Docket Item # 8  
BAR CASE # 2008-0242

BAR Meeting  
January 7, 2009

**ISSUE:** Alterations  
**APPLICANT:** Virginia Magestic for Bob and Rebecca Sutton  
**LOCATION:** 713 South Pitt Street  
**ZONE:** RM/Residential

**BAR CASE #2008-0242**

Figure 7: Rear portico elevations and specifications

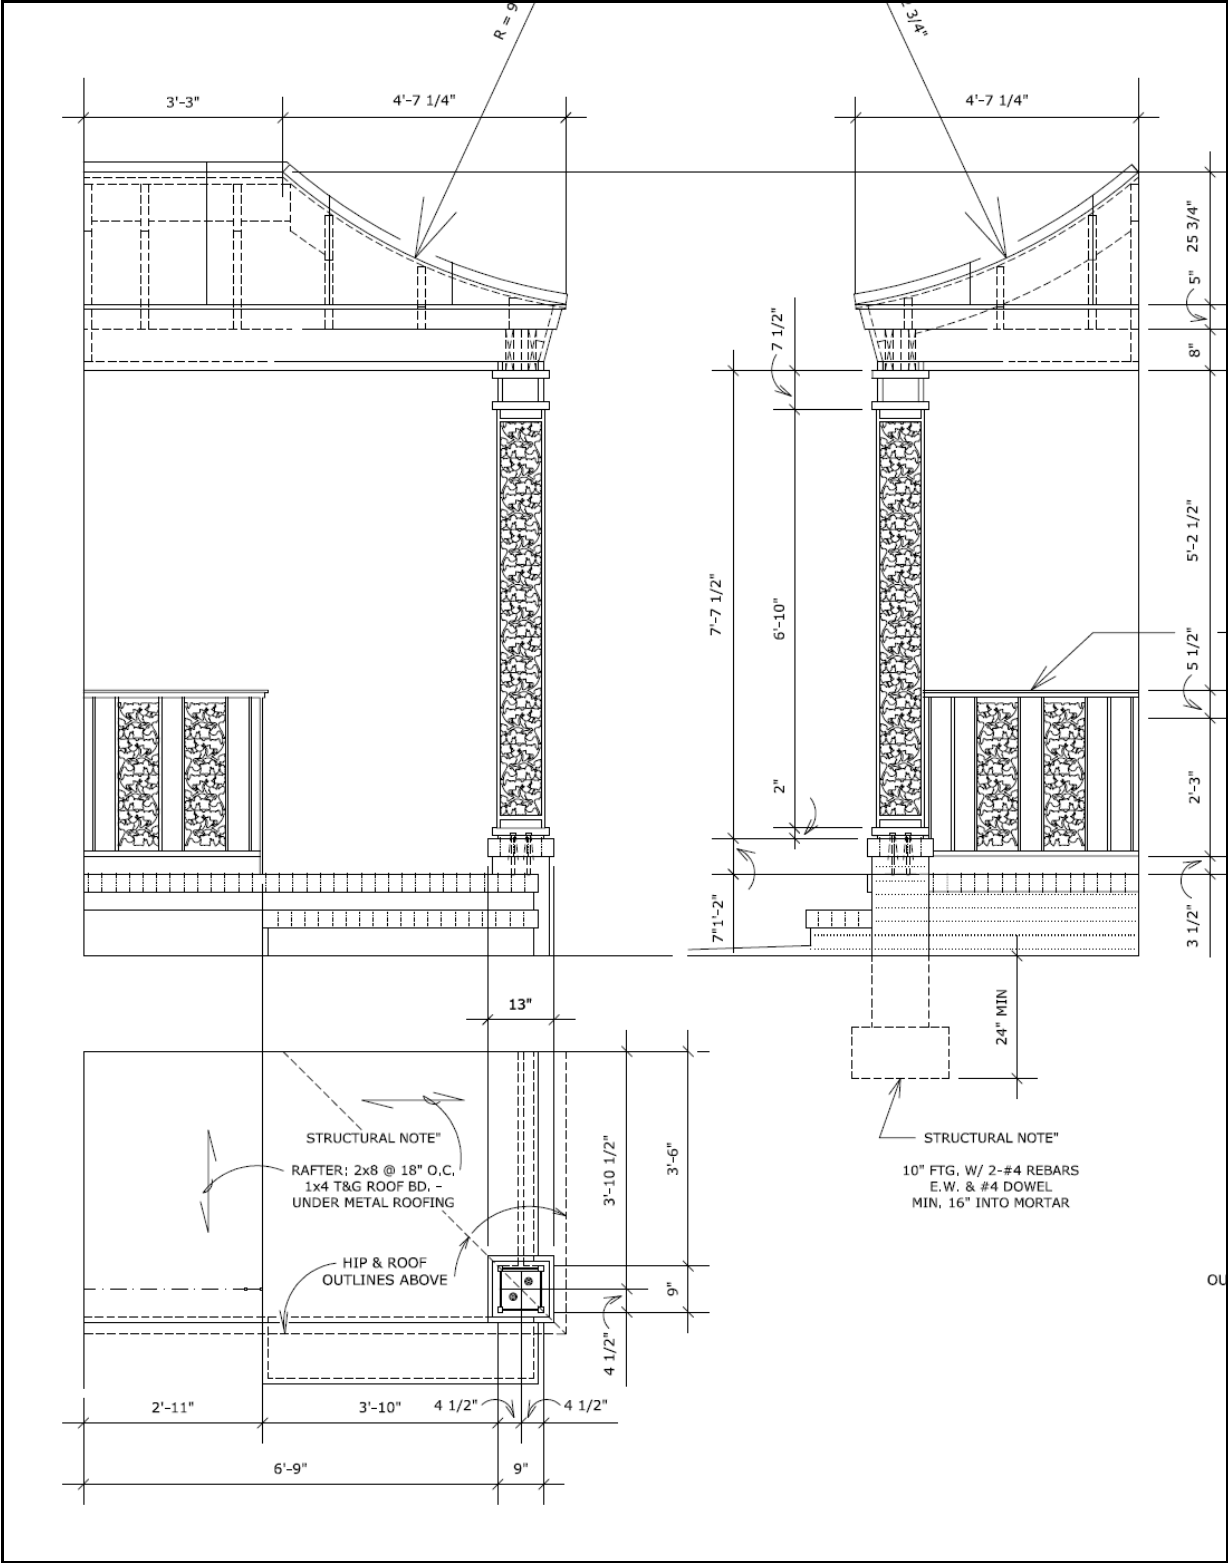
Staff's only concern pertains to the materials submitted by the applicant, which are somewhat confusing. The existing railings shown on the proposed elevations are not consistent with the ironwork shown on the rear and front portico details, which accurately reflect the floral pattern alternating with simple pickets (see photos). Instead of installing the columns with the floral pattern from top to bottom, Staff recommends that the applicant install new iron columns with a small amount of the decorative floral pattern.

Staff recommends approval of the application with the condition that the iron columns do not have the floral pattern from top to bottom, but rather a small amount of the decorative floral pattern.
